CZECH SPORT
AIRCRAFT

SERVICE BULLETIN

No.: SB-CR-075

MODEL AFFECTED:	PS-28 Cruiser SportCruiser / PiperSport aircraft operating under EASA rules
SUBJECT:	Inspection and eventual replacement of carburetor circlip for Rotax engine type 912 (Series)
AIRCRAFT AFFECTED:	<p>All aircraft with Rotax engine types 912 Series if at least one of the A), B) or C) below mentioned criteria applies.</p> <p>Criterion A) Engine serial number:</p> <p style="padding-left: 40px;">From S/N 6784306 up to S/N 6787000 inclusive From S/N 9565001 up to S/N 9573266 inclusive From S/N 9573268 up to S/N 9573271 inclusive From S/N 4924905 up to S/N 4925000 inclusive From S/N 9139001 up to S/N 9139252 inclusive From S/N 9563601 up to S/N 9565000 inclusive</p> <p>Criterion B) Carburetors:</p> <p style="padding-left: 40px;">1/3 part. no. 892530: From S/N 145021 up to S/N 191489 inclusive From S/N 191491 up to S/N 191496 inclusive From S/N 191498 up to S/N 191499 inclusive From S/N 191502 up to S/N 191513 inclusive S/N 191515 / S/N 191517</p> <p style="padding-left: 40px;">2/4 part. no. 892535: From S/N 144903 up to S/N 191601 inclusive From S/N 191603 up to S/N 191617 inclusive From S/N 191631 up to S/N 191637 i

Fig. 1: Rotax 912 carburetor

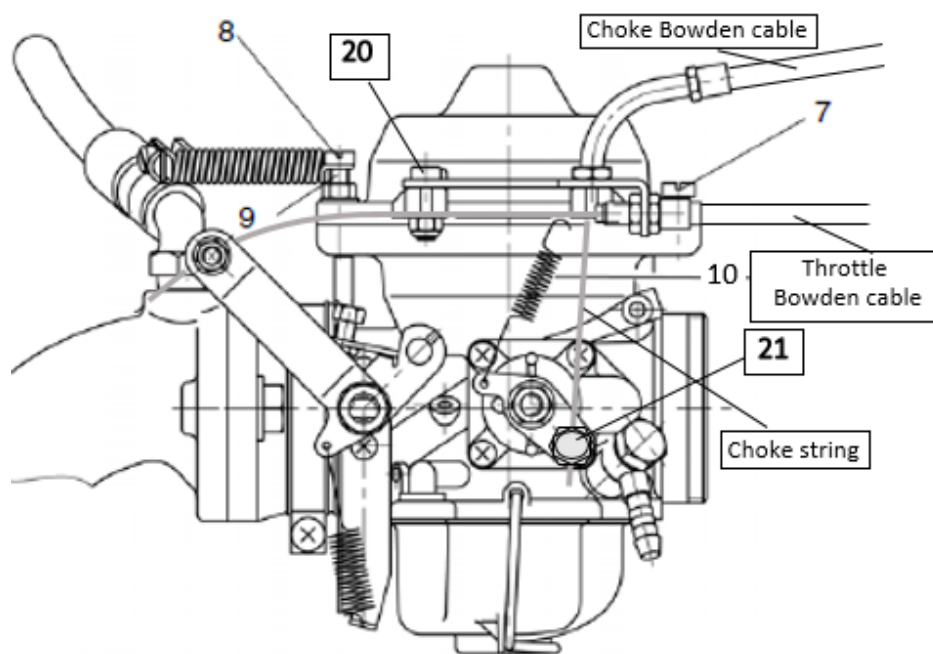
1. Check the aircraft / engine logbook and maintenance documentation, if this Service Bulletin has already been accomplished.
2. Check the criteria given in Section "AIRCRAFT AFFECTED", if the aircraft is affected by this Service Bulletin.
3. Move the aircraft to a suitable place to perform the work.
4. Remove the engine upper cowling (see the CR-MM-1-0-00, the latest revision).
5. Disconnect the battery terminals (see the CR-MM-1-0-00, the latest revision).
6. Remove the oval head screw (20), see Fig. 1.
7. Loose the choke screw (21) and release the choke control string, see Fig. 1.
8. Cut the tapes fixing throttle and choke Bowden cables.

9. The carburetor circlips part no. 945785 must be replaced by carburetor circlips part no. 945786. For replacement, follow instructions in the Supplement CR-MM-1-0-00-S-07 (see also the ROTAX Service Bulletin no. SB-912-073).
10. Screw and fix the oval head screw (20), see Fig. 1.
11. Install the choke control string and fix the choke screw (21), see Fig. 1.
12. Use fixing tapes and attach and fix the throttle and choke Bowden cables.
13. Adjust the choke control string, see the CR-MM-1-0-00, Point 10.4, latest revision.
14. Connect the aircraft battery terminals.
15. Install the engine upper cowling (see the CR-MM-1-0-00, latest revision).

The carburetor circlip p/n 945785 must not be used and must be replaced by the circlip p/n 945786.
